PELICAN™ 1300 PROTECTOR CASE™

TECH BULLETIN | 11/01/2022

GEN 2 NOW AVAILABLE

1300

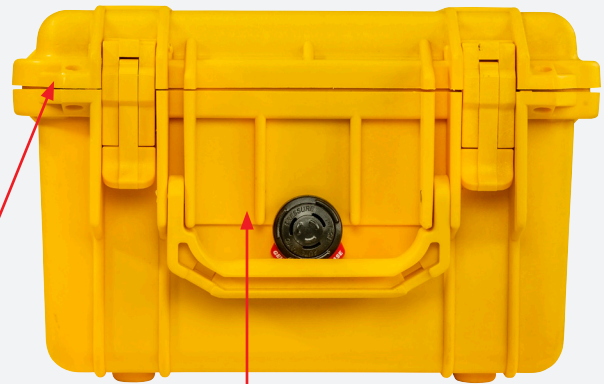
- » External Ribbing Removed On Front
- » Re-positioned PRV
- » Excess Material Removed From Padlock Areas
- » Excess Material Removed From Inside Wall
- » Exterior Dimensional Differences
- » Interior Dimensional Differences

INTERIOR LENGTH			INTERIOR WIDTH		
	GEN 1	GEN 2	DIFFERENCE	GEN 1	GEN 2	DIFFERENCE
BASE	9.510"	9.528"	+0.018"	7.322"	7.321"	+0.001"
LID	9.284"	9.525"	+0.241"	7.21"	7.312"	+0.102"
